To: Rob Balland, Paramounte Engineering
From: Brian Chambers, Assistant Director, 910.342.2782
CC: File;
Date: 10/17/2023
Re: The Avenue TRC Rev 3

SIGNAGE AND PAVEMENT MARKING PLAN Sheet C-2.22: Signage and pavement marking plan comments from Signs & Markings Manager. Images are attached for reference.

Project Name: **THE AVENUE**

TRC Date: **10.16.2023**

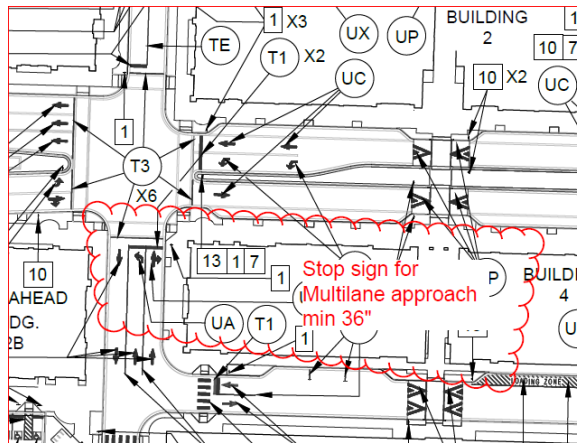
1. Remove right-turn only sign and add a stop sign, in an advance of crosswalk/ADA ramp for the driveway off Harborview Way immediate to Military Cutoff Rd.
